Application of Rohail Hada for a Special Land Use Permit (SLUP) to allow fuel pumps in Tier 1 of the Bouldercrest Overlay District and the C-1 (Local Commercial) zoning district, at 2510 Bouldercrest Road.

PETITION NO: N10-2026-1269 SLUP-26-1248268

STAFF ANALYSIS

CASE NO.:	SLUP-26-1248268	**File ID #:** 2026-1269
Address:	2510 Bouldercrest Road, Atlanta, GA 30316	**Commission Districts:** 03 and 06
Parcel ID(s):	15 077 02 011	
Request:	Application of Rohail Hada for a Special Land Use Permit (SLUP) to allow fuel pumps in the C-1 (Local Commercial) zoning district and Tier 1 of the Bouldercrest Overlay District.	
Property Owner(s):	Rohail Hada	
Applicant/Agent:	Rohail Hada	
Acreage:	1.066	
Existing Land Use:	Vacant convenience store and fuel pumps	
Surrounding Properties:	**North:** Forested land, recreational land, and a single-family detached subdivision **East:** Clifton Church Road separates subject site from a shopping plaza **South:** Bouldercrest Road **West**: Bouldercrest Road separates the subject site from multi-family apartment complex	
Adjacent Zoning:	**North:** MZ (Multiple Zoning), R-75 (Residential Medium Lot-75) **East:** NS (Neighborhood Shopping) and C-1 (Loca

CONCEPT PLAN I FOR:
2510 BOULDERCREST ROAD
ATLANTA, GA 30316

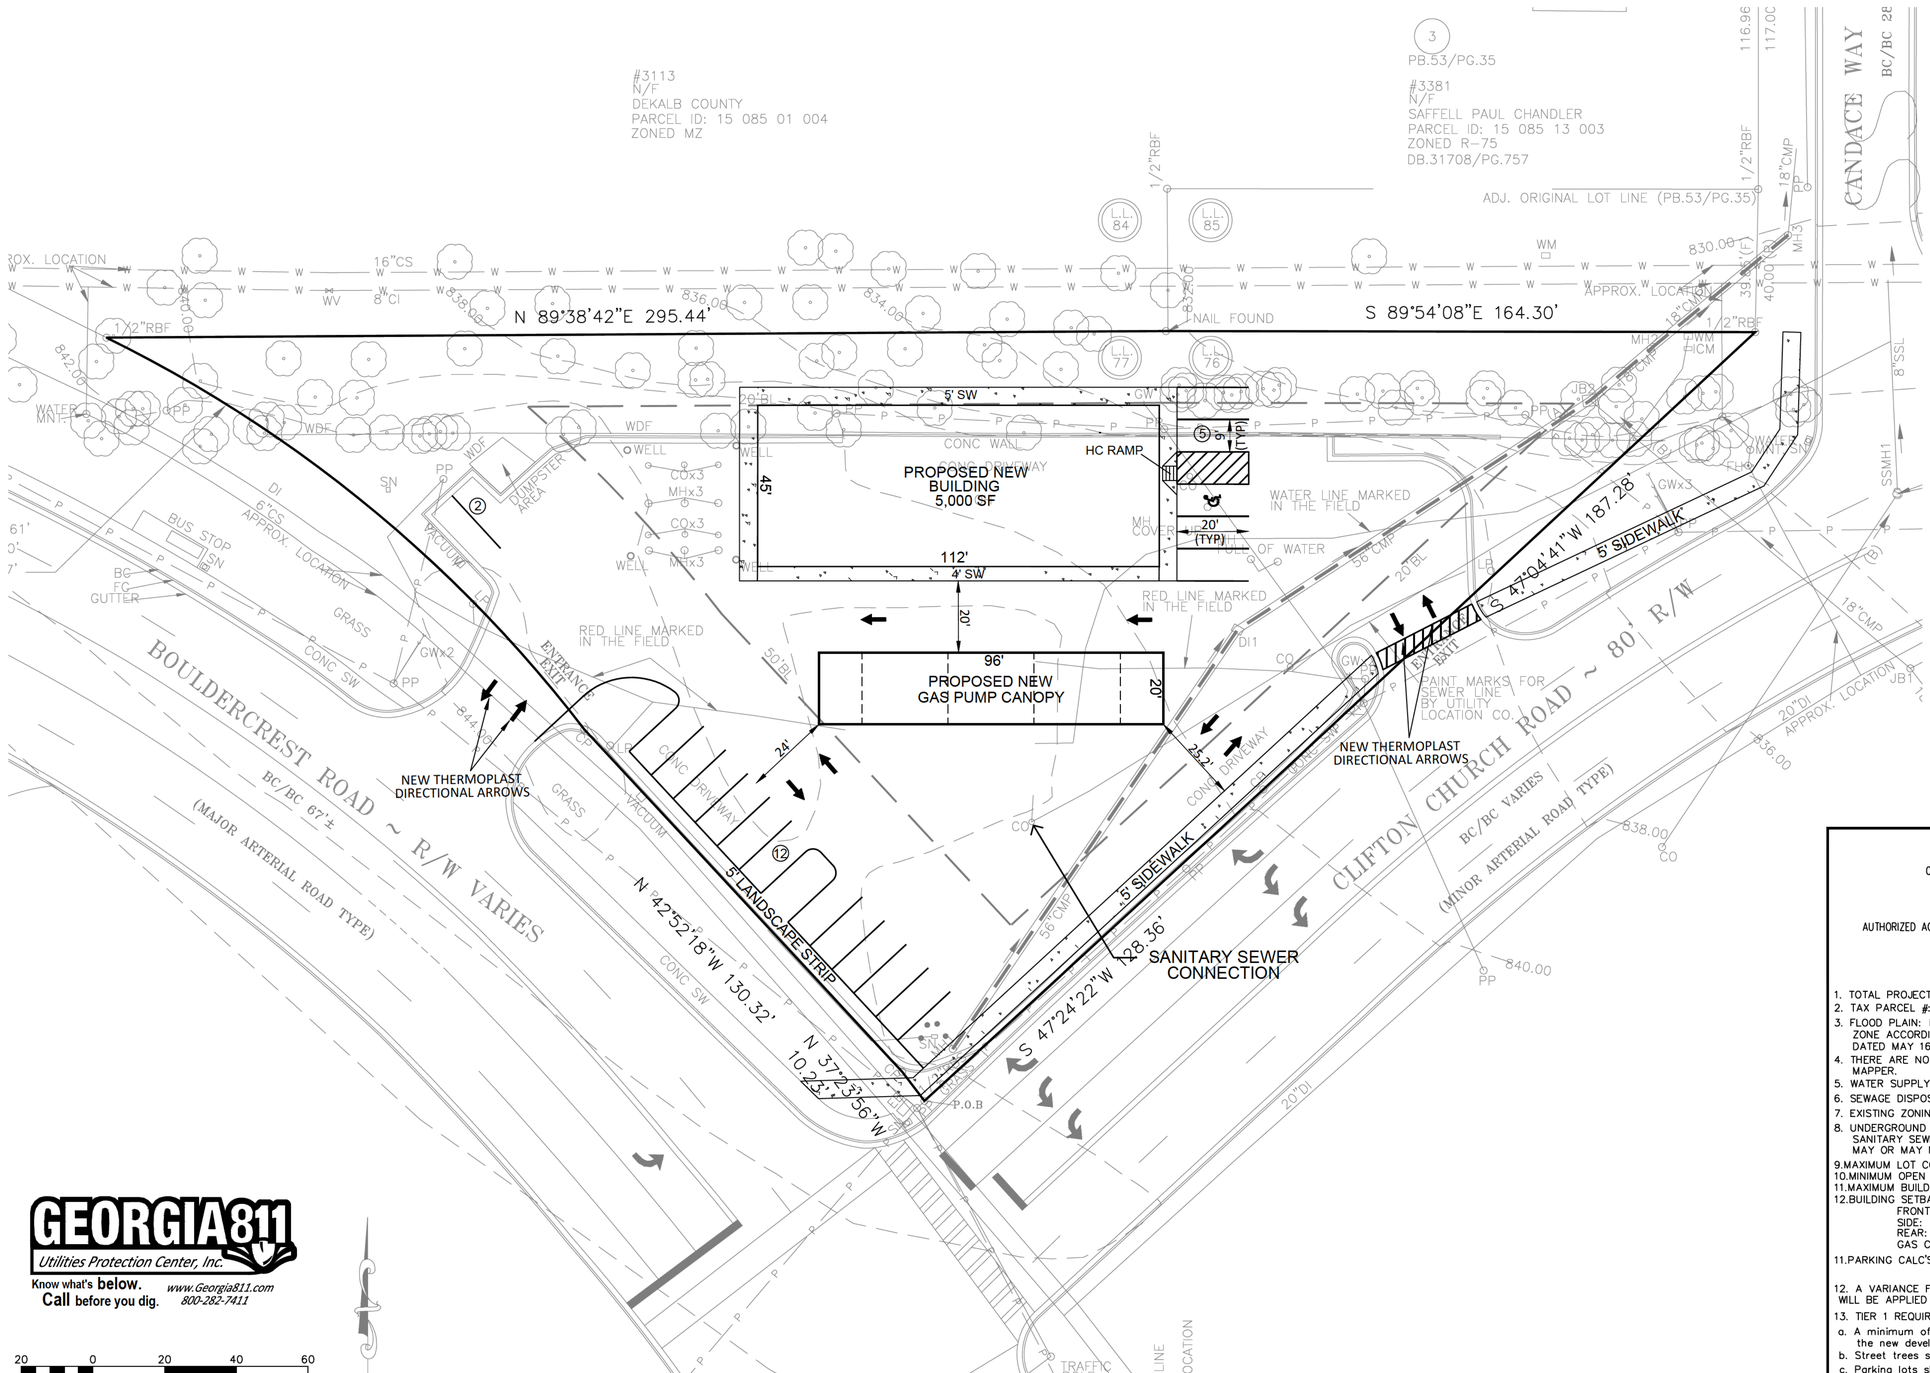
Staff identified several site plan deficiencies related to the Bouldercrest Overlay Standards (Section 3.39.6.- *Standards Applicable to all Tiers*). Subsections C.1 and C.2 require a 10-foot sidewalk, a 10-foot landscape strip, and trees spaced no more than sixty (60) feet apart. Additionally (if not already in place) a right-of-way dedication of seventy-five (75) feet from the centerline of roadway is required - all public infrastructure must be within the right of way. The proposed site plan "*Concept Plan I*" dated, 6/19/2026 shows only a 5-foot sidewalk and 5-foot landscape strip along Clifton Church Road and does not demonstrate compliance with the required tree spacing. Furthermore, convenient pedestrian pathways connecting street sidewalks to each building entrance, are required by Subsection C.4. Any proposed signage must comply with Subsection B and Chapter 21. No additional material concerns were identified by the Interdepartmental comments.

The site's irregular shape and frontage along Bouldercrest Road and Clifton Church Road constrains the buildable area. Compliance with the Bouldercrest Overlay's streetscape, pedestrian access, and right-of-way requirements have not been demonstrated. The proposal appears inconsistent with Supplemental Regulations Section 4.2.28 I., which requires 3,960 feet (three-fourths of a mile) of separation between a new convenience store and an existing small box retail discount store. A Family Dollar is located approximately sixty-five (65) feet away, across the street. The proposal does however appear to satisfy Supplemental Regulations in Section 4.2.8, subject to plan documentation confirming that alcohol sales and storage occupy no more than 20 percent of the gross floor area, as required by Subsection D.

Public services and utilities in the area appear limited. Specifically, District 3 Community Council voted for a deferral for additional community engagement discussions around desired goods and services. The site's proximity is just north of Route 285- an area characterized by warehouses and truck terminals—supporting its functional suitability, with adequate street capacity and good traffic flow. Two (2) access points provide ingress, egress, and emergency access. However, the plan does not show the required safe and direct pedestrian connections from the public sidewalk to building entrances, as required by Section 3.39.6 Subsection C.4.

☑ Possible Variances: Variances will likely be sought. Subject site is a irregular shaped lot (triangle) which may impact setbacks requirements. Site plan is still in conceptual stages & will need display requirements outlined in 3.39.4.
